**RANCHO SECO NUCLEAR GENERATING STATION  
UNIT NO. 1**

**SUPPLEMENT NO. 1**

**PRELIMINARY SAFETY ANALYSIS REPORT**

DOCKET 50-312

FIGURE 5.1-1  
 REACTOR BUILDING  
 TYPICAL DETAILS  
 SHEET 2

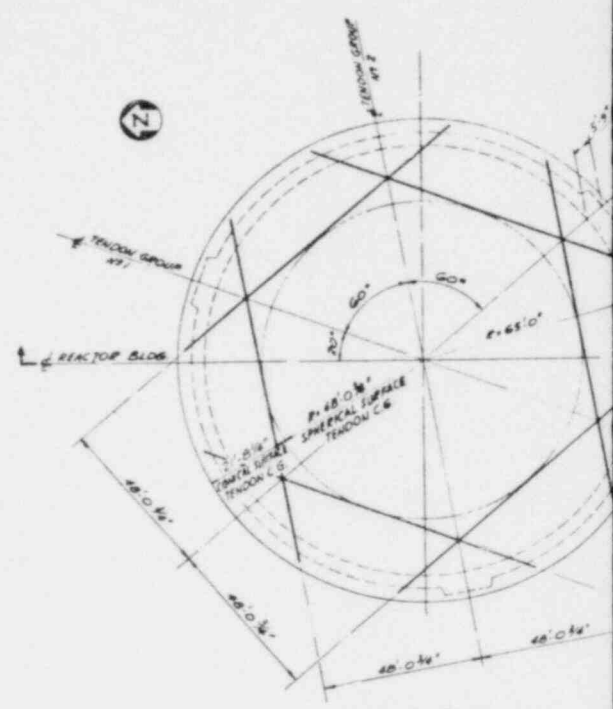
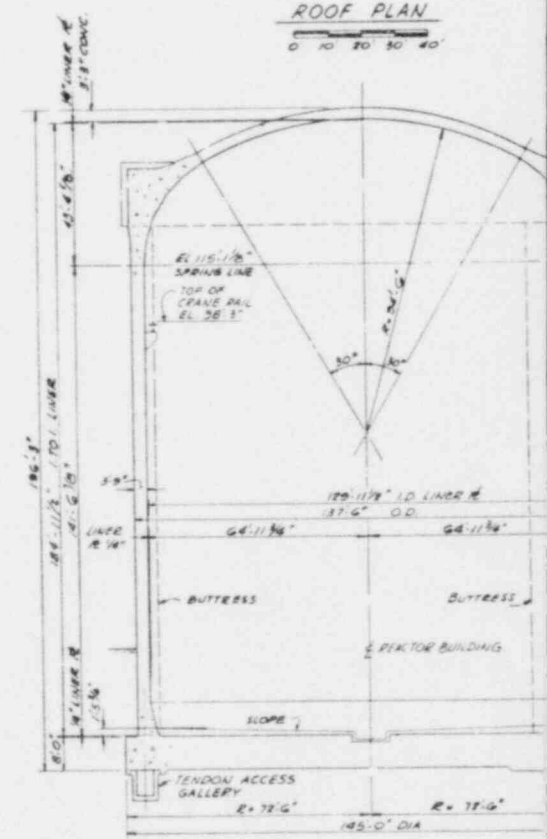
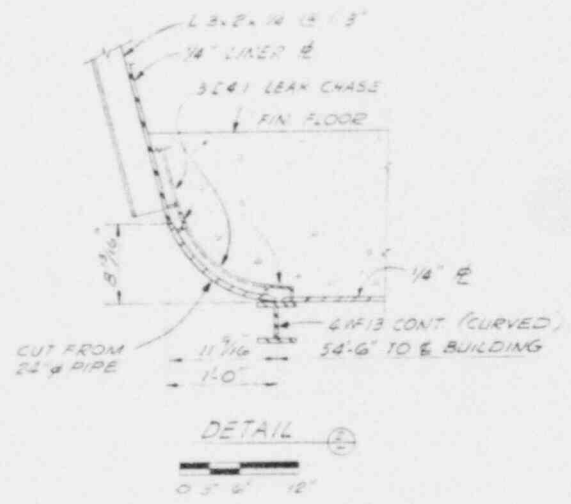
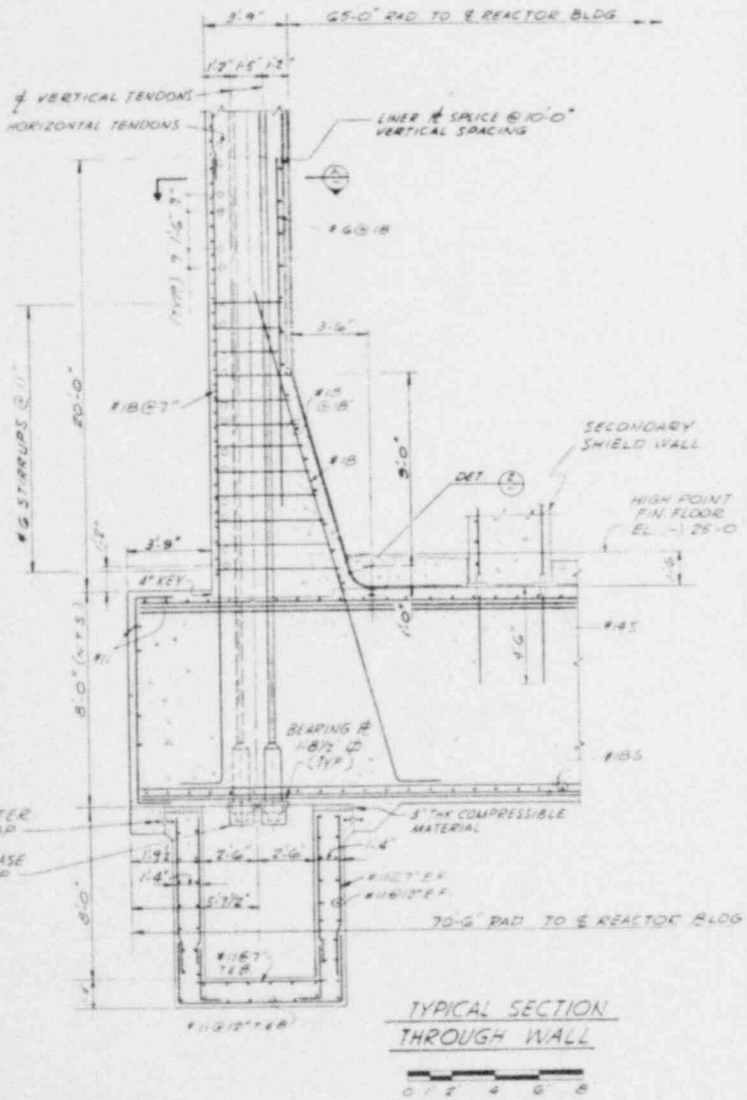
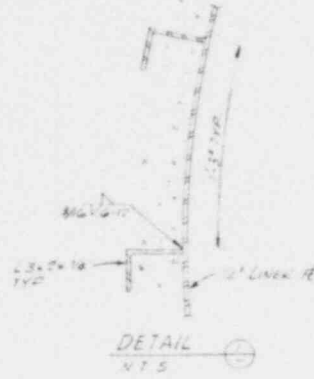
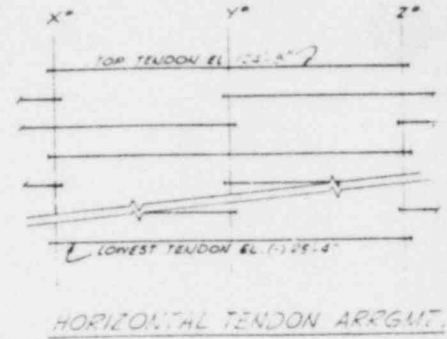
- (a) A preliminary design drawing of the containment, presenting details of the base slab, dome ring beam, cylinder-slab juncture, vertical buttresses and inspection gallery; showing reinforcing, prestressing, and liner features, including liner anchors;
- (b) Scaled load plots for moment, shear, deflection, longitudinal force, and hoop tension, in order that an appraisal can be made of the significance of the various loadings which influence the containment design; Provide these plots as a function of containment height for prestress, dead, pressure, design earthquake, wind, liner thermal (normal and accident) and concrete thermal (normal and accident) loading;
- (c) The normal operating transient and steady state thermal gradients to be used in the design of the containment for typical winter and typical summer day;

- (a) The preliminary design details of the containment structure are shown in Figure 5.1-1, 5.1-2, and 5.1-3 of Section 5 in the PSAR. These figures have been modified to include the requested preliminary information which is available.
